MONITORING YEAR 3 ANNUAL REPORT FINAL

WYANT LANDS MITIGATION SITE

WYANT LANDS MITIGATION SITE
Monitoring Year 3 Annual Report

2019 Aerial Imagery

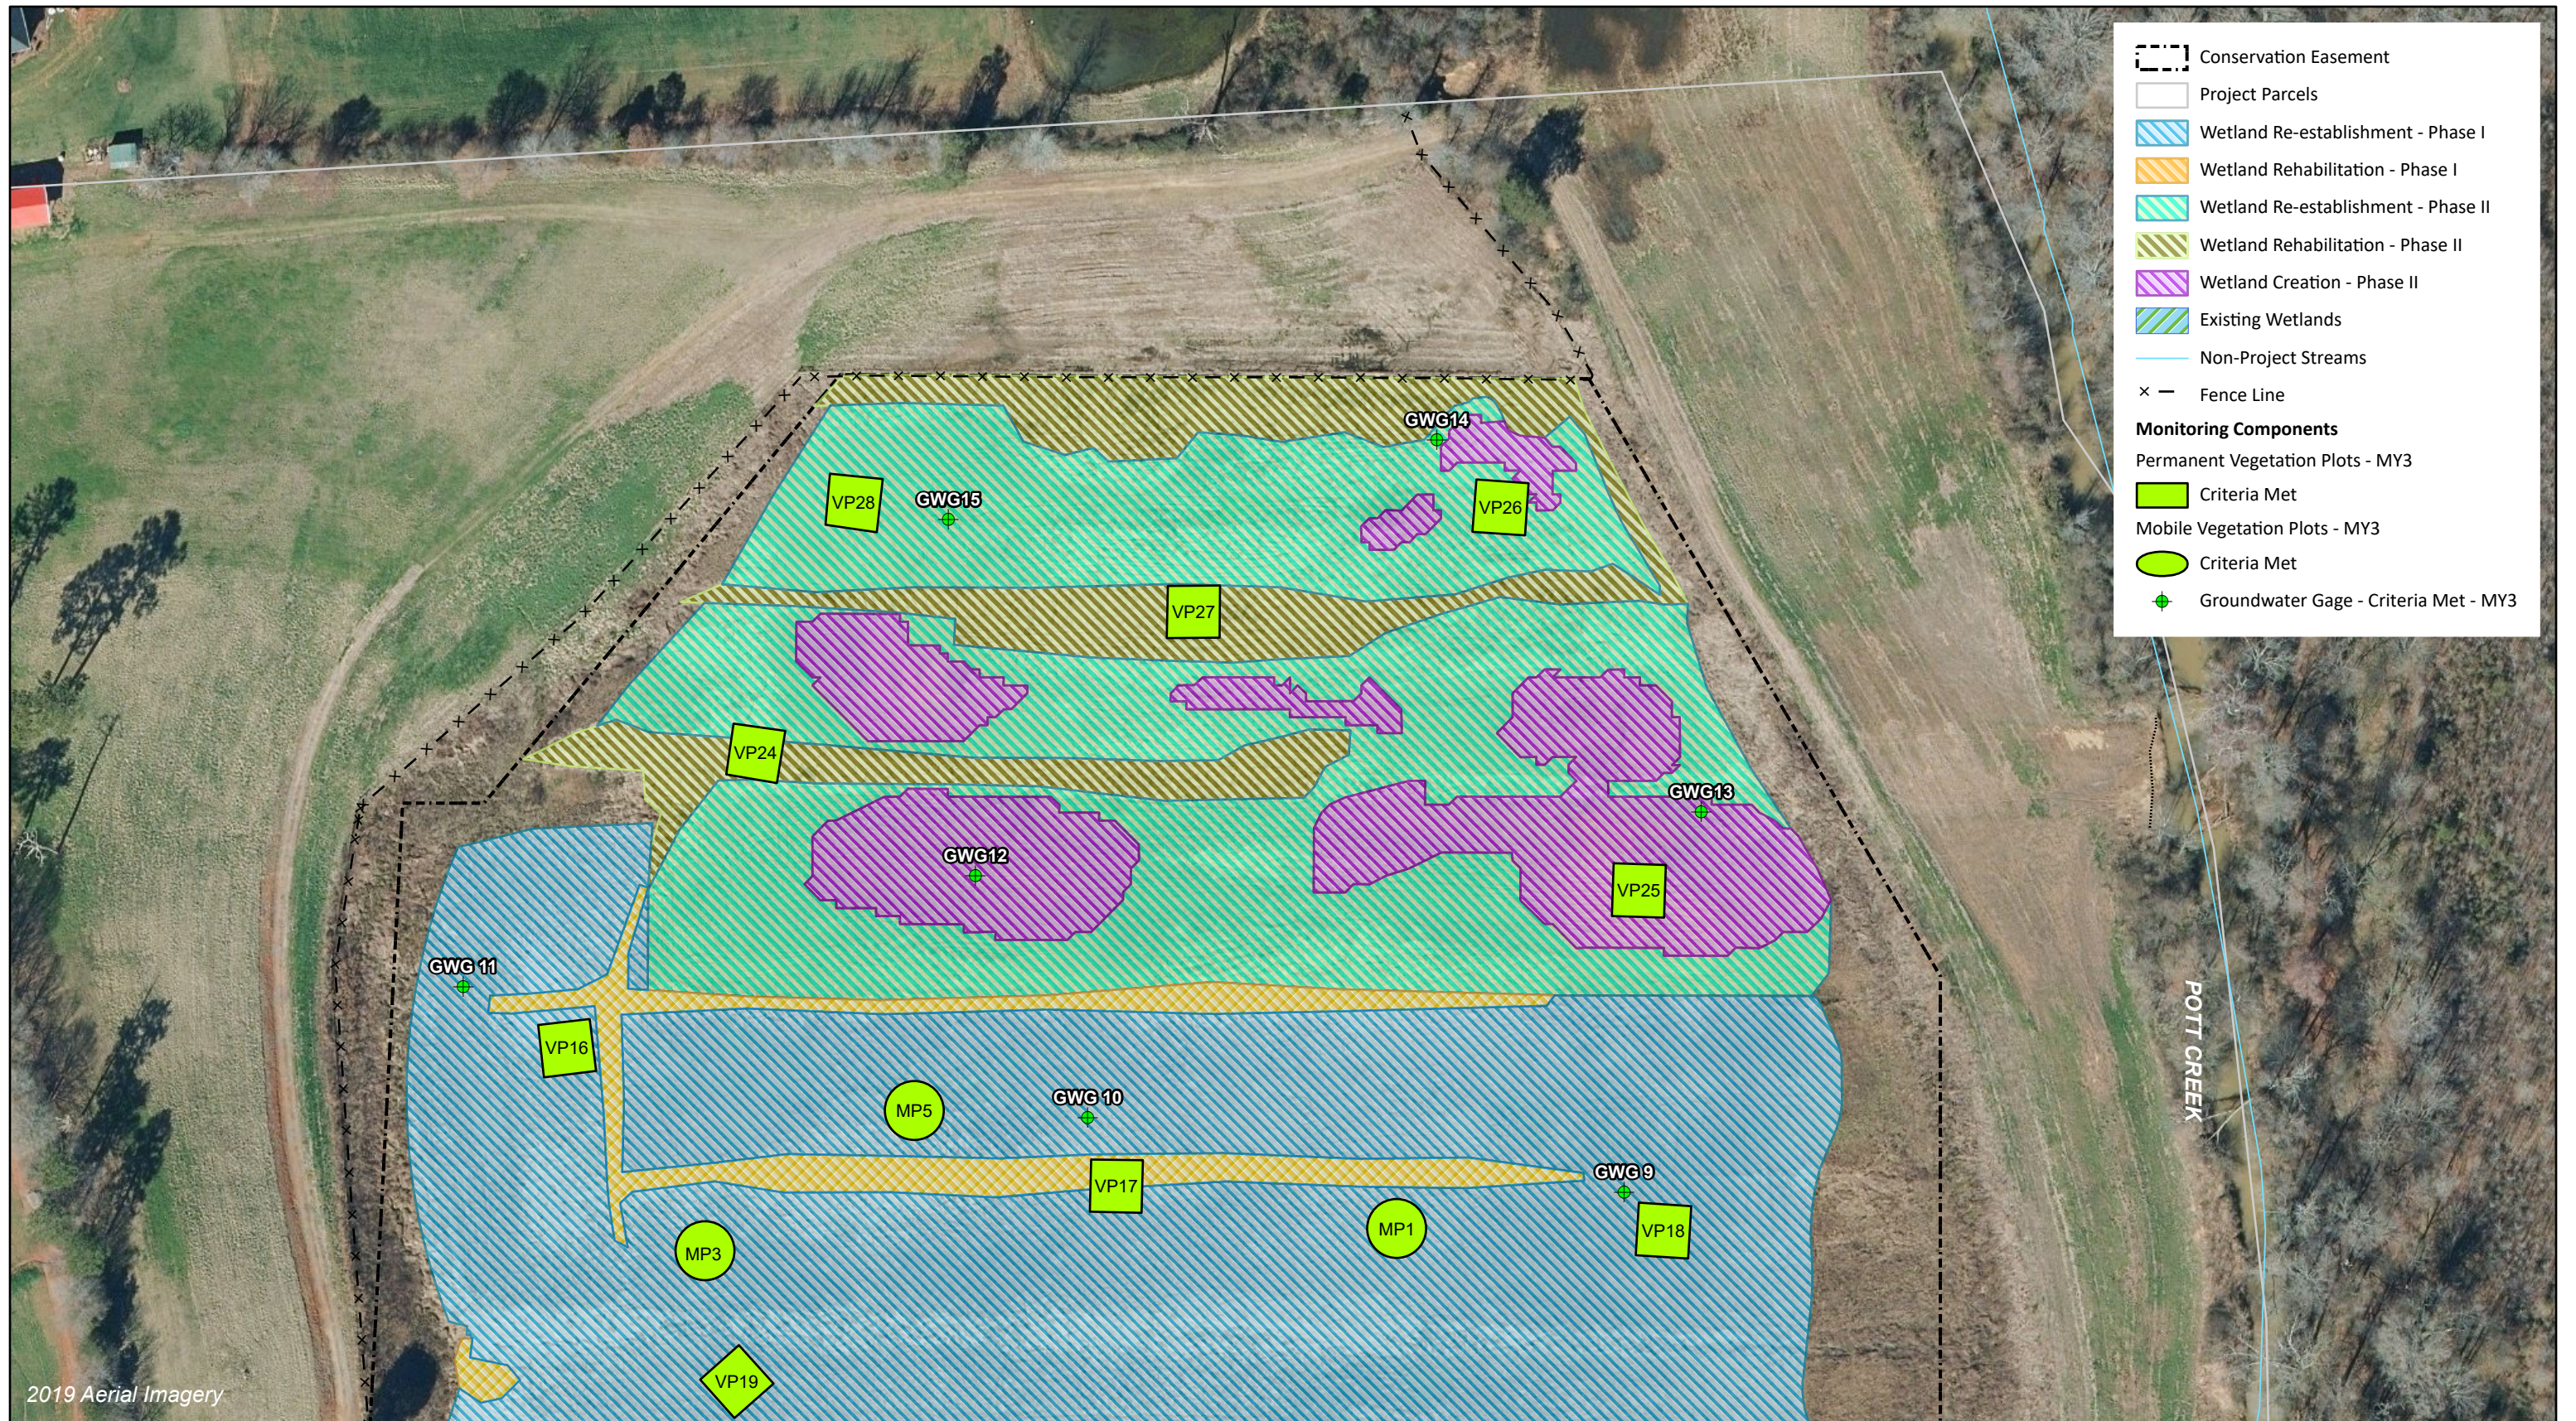
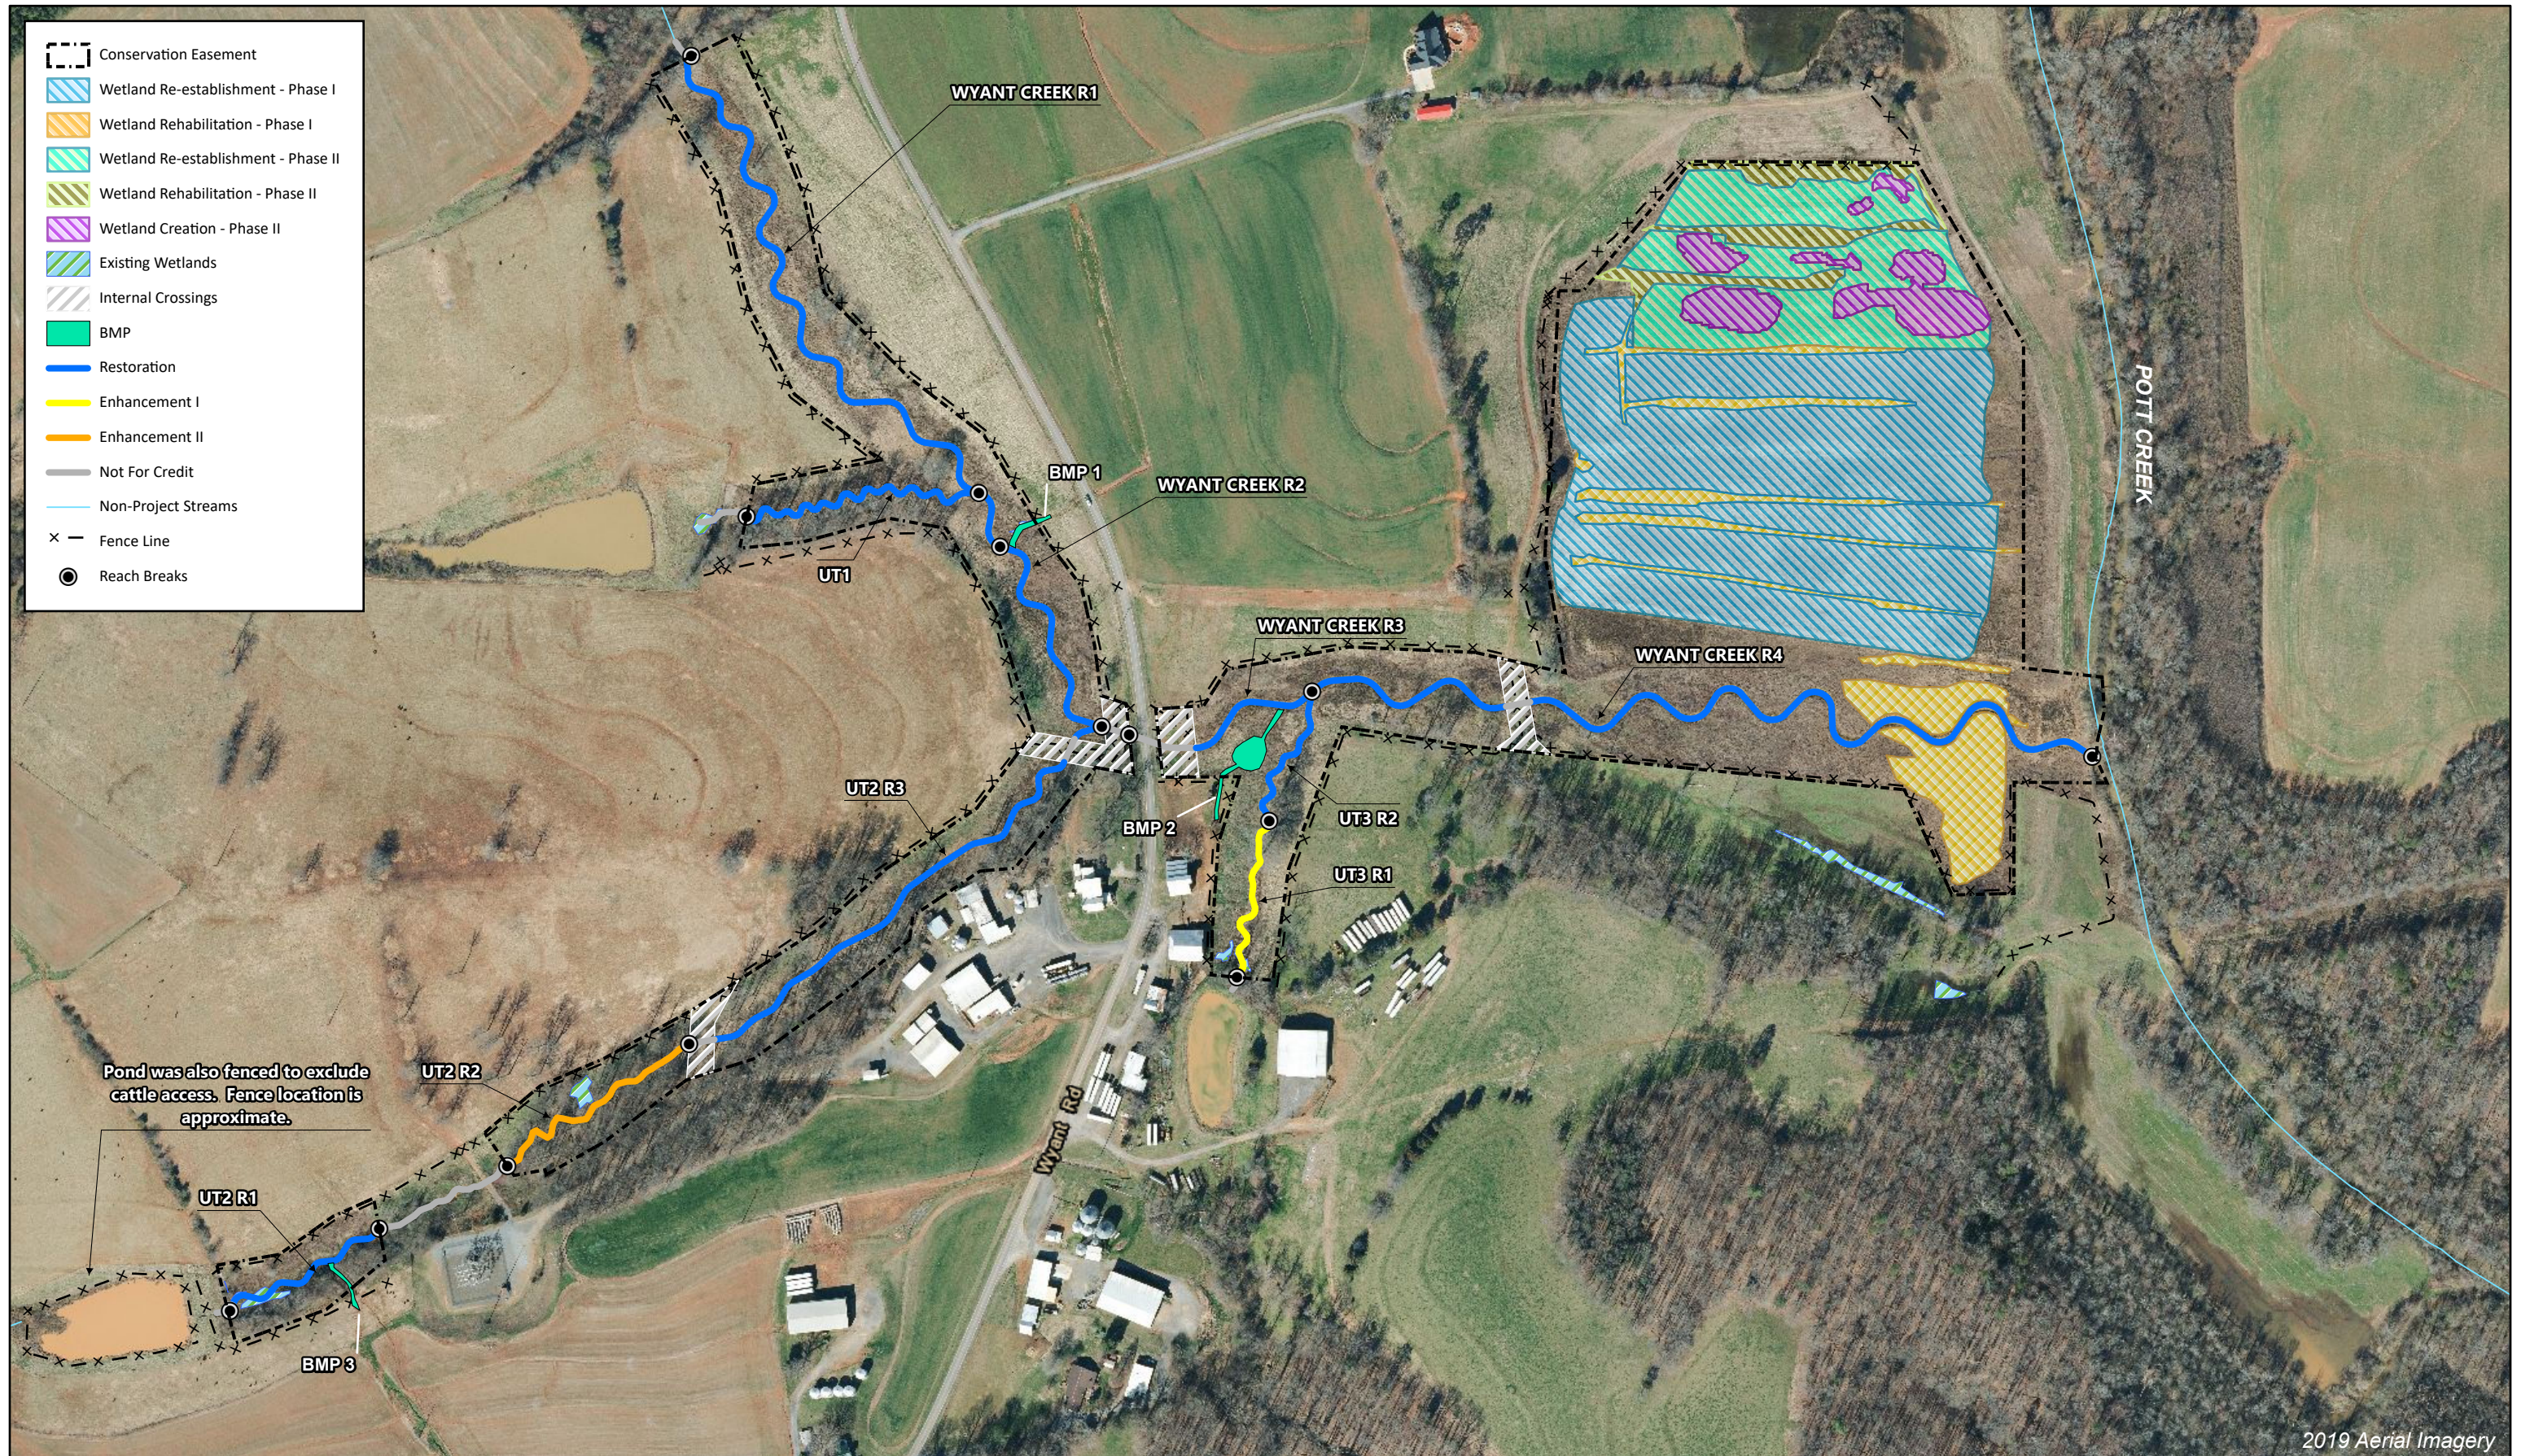
- *Table 1: Project Quantities and Credits; CCPV Maps (Figure 1) & Project Asset Map (Figure 2): There are no wetland IDs on the CCPV maps or asset map. How do the 5 wetland groupings correspond to the CCPV maps (Figure 1) & asset map (Figure 2)? Please identify the wetland groupings on the maps or provide some appropriate description of each grouping in the report text.*

Wildlands Response: Wetland groupings in Table 1: Project Quantities and Credits were updated with their corresponding wetland mitigation categories (e.g., Re-establishment Phase I, Wetland Creation Phase II) for ease of understanding.
